# CITY OF ALBUQUERQUE

RE: Lot 7 Block 3 Volcano Cliffs Unit 2 SAD 227 5619 Kimberlite Dr. NW **Grading and Drainage Plan Engineers Stamp Date 7/13/2022 (E10D119)** Pad Certification Date 8/18/2022

# 5619 Kimberlite Drive NW GRADING AND DRAINAGE PLAN

SHEET# C1 Lingineering JOB#

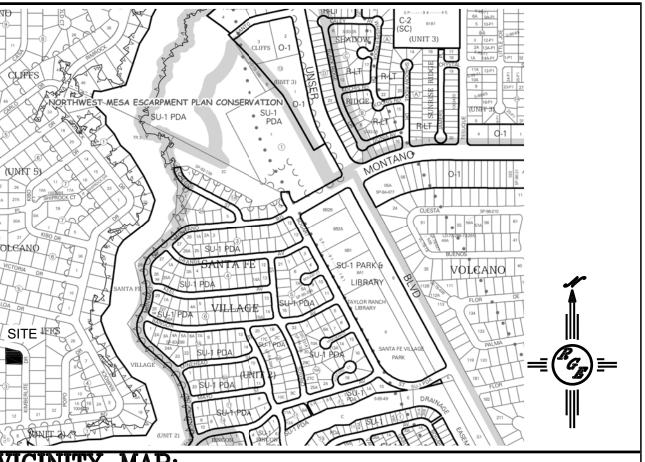
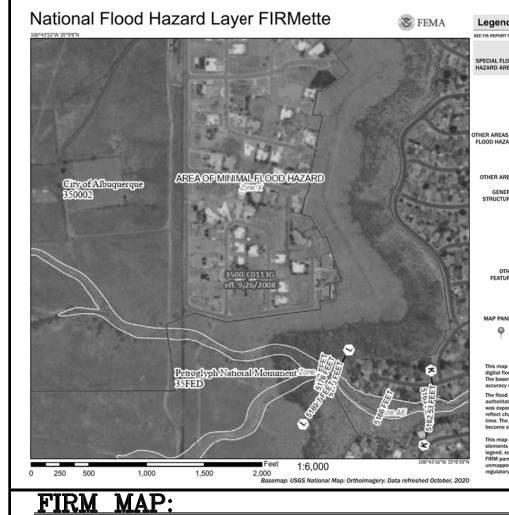
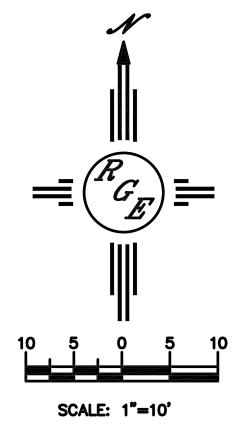
PO Box 1293 Based upon the information provided in your submittal received 8/22/2022, this plan is approved

Reiterate to the Owner/Contractor that a separate permit for a garden/retaining wall must be obtained, with the approved G&D plan and Pad Certification. Advise the owner &

Contractor that dirt is not allowed in the public right of way to climb the curb. Crusher

fines or lumber is allowed. If dirt is used this will delay going forward with the construction

of the home.

www.cabq.gov Prior to Certificate of Occupancy release, Engineer Certification per the DPM checklist of this

plan will be required.
